DWN J. BRUNO	DATE 9508-17	PROD ASSUR M. Gray	DATE 9508/22	BOEING HELICOPTERS DCN DRAWING CHANGE NOTICE CODE IDENT. NO. 77272			DWG NO. 145G0061			
CHK C. LACHALL	WT _____	REASON REVISE DWG TO SHOW ADDITION OF HOIST RINGS TO TORQUE ADAPTER			SH 1 OF 1	REV B	DWG SH			
ENGR M. J. McNamee	MAT'L & PROC _____							MODEL/ITEM NO. CH-47D, 414-100/26300		
STRUCT	ORG S. Balick				95-08-24	CODE D IMP (REF PDS TASK 21219)			CHANGE NO. PRR 95000 E	
PROJ Lift Assist	CUST Wm Cottobit - 9509/19	ORIGIN GSE 1459	CLASS PER MIL-STD-480 <input type="checkbox"/> CLASS I <input checked="" type="checkbox"/> CLASS II		SPARES AFFECTED <input checked="" type="checkbox"/> YES <input type="checkbox"/> NO					
PL SH/ZONE	REPLACES _____	QTY REQ'D _____	CODE IDENT _____	PART OR IDENTIFYING NO. _____	NOMENCLATURE OR DESCRIPTION _____	ZONE _____	MATERIAL AND SPECIFICATION _____	HT TR _____	FINISH _____	PT MK 9509/12

ZONE B6 REVISED DWG TO SHOW ALTERNATE LOCATION FOR SLING.

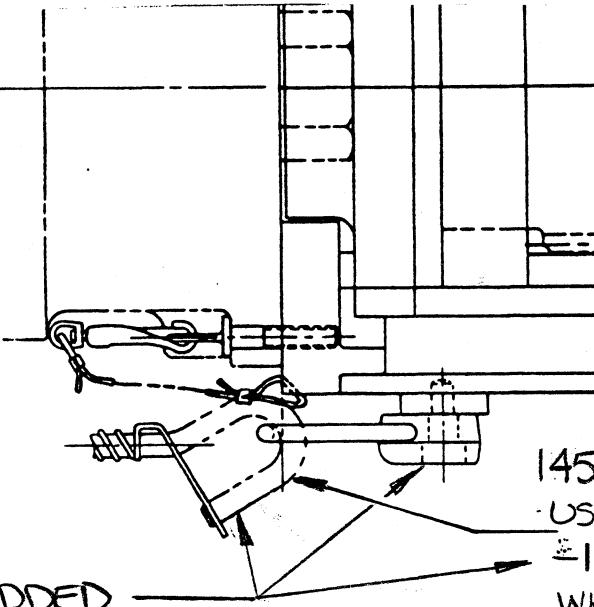
145G0007-1 LIFTING SLING (REF)
USE HOIST RINGS FOR LIFTING
-1 TORQUE TUBE ADAPTER
WHEN TORQUE APPLICATOR
IS NOT INSTALLED

(ADDED)
